TP3 Stressed Sensitivity Test: Process for Determining ISI Impairments

Comments on Sorting into Categories (step 3) and beyond

Lew Aronson – Finisar

December 14, 2004

Selection Flow Chart

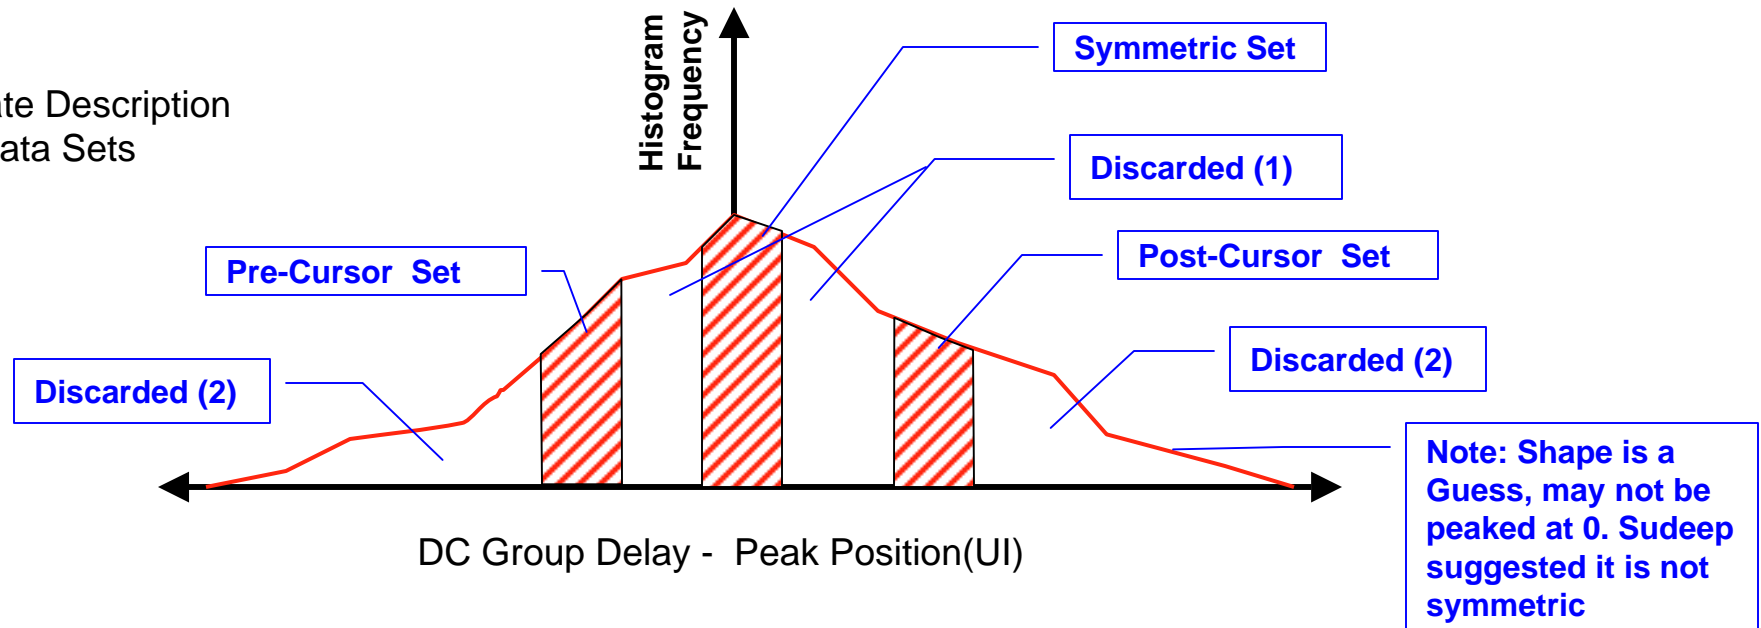
- Sudeep provided excellent first step of sorting models down into 3 categories.
- Metric of difference between main peak and DC group delay ('center of gravity') seems to work very well
- One question is why use particular criteria shown (e.g. $+20\% \pm 3\%$ of absolute delay).
- Propose following way of thinking of selection process. Histogram of results sorted by DC group delay - Peak :

Approximate Description
of Bhoja Data Sets

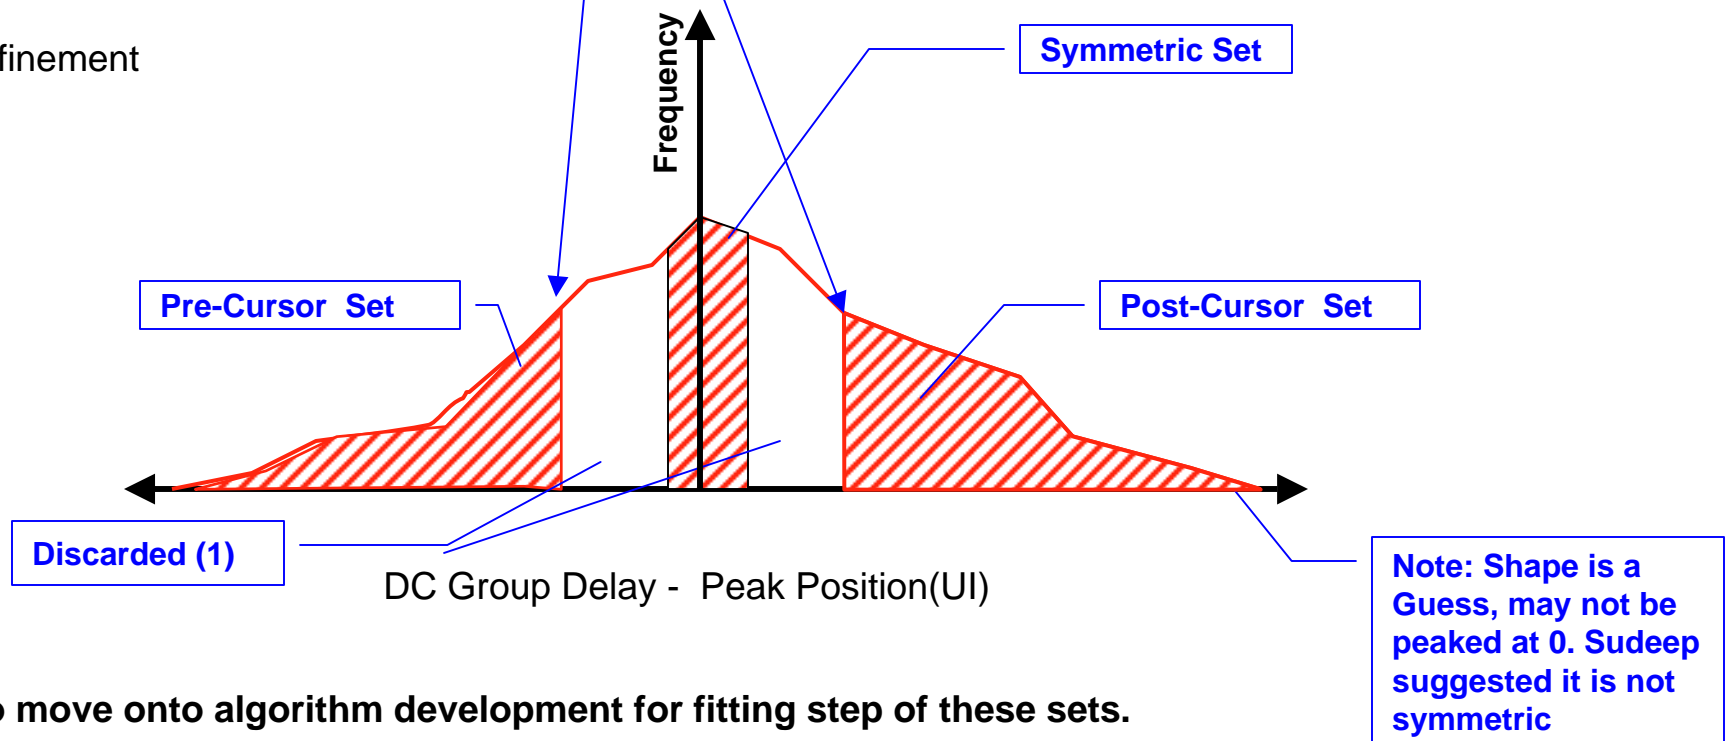
- Discarded IPRs between symmetric and pre and post cursor sets "Discarded (1)" probably not clearly in any bin.
 - Probably worth discarding.
- Discarded IPRs with larger differences "Discarded (2)" are probably worth keeping.
- It may be interesting to see the difference in shapes within subsets of larger DC – Peak differences, but perhaps is not important if we simply choose to retain them all

- Keep all IPRs larger than a certain DC – Peak Value, chosen to provide distinctly pre and post-cursor like IPRs
- If number of sets is unmanageably large, simply tighten the PIE-D metric window. Currently chosen as 4.5 ± 0.5 dB, go to ± 0.1 dB for example.
